TOLEDO-LUCAS COUNTY PLAN COMMISSIONS

REF: SUP-2001-19

SUBJECT: Request for Special Use Permit to add a second drive-through lane to an existing fast food restaurant

SITE PLAN

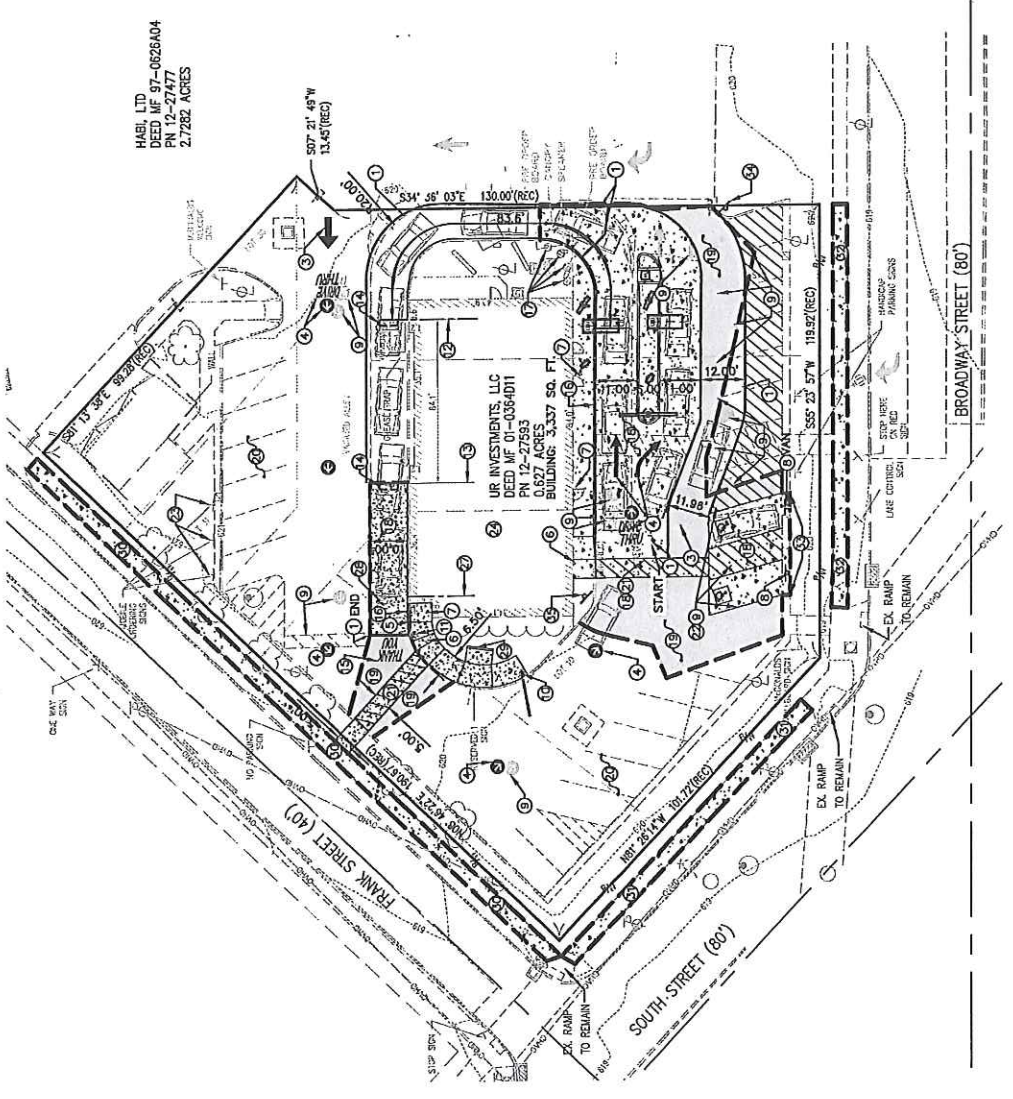
15. The increase to 12 feet to the bypass lane will meet the needs for Fire/EMS accessibility.

17. Approval of the Special Use Permit will lapse after one (1) year if the criteria listed in TMC 1111.0707 have not been met.
18. Whenever a parking lot extends to a property line, sidewalk, planting strip, or building, a wheel stop device consisting of a concrete stop, a permanent concrete curb, an expanded sidewalk or other suitable restraint as approved by the Planning Director must be installed to prevent any part of a parked motor vehicle from extending beyond the property line, overhanging a pedestrian walkway or sidewalk, or damaging any structure or landscaping (TMC§1107.1907(A)) **(Acceptable depicted on site plan).**

19. Landscaping for the site shall adhere to the approved Landscape Master Plan via case D-12-02. The applicant shall obtain a copy of said plan from the Plan Commission and submit a final landscape plan that is compliant with the original approval and the Historic South guidelines. Screening shall be shown on revised site plan.

21. Provide at least seven bicycle parking slots as required for the off-street parking Schedule A (**Acceptable depicted on site plan**).
22. Litter receptacles, for the use of parking area users and others, must be provided in off-street parking areas in accordance with the provisions of Part 9 Street, Utilities and Public Services Code, Section 963.22. A litter receptacle is treated as an accessory structure and must adhere to the criteria outlined in (TMC§1107.1910).
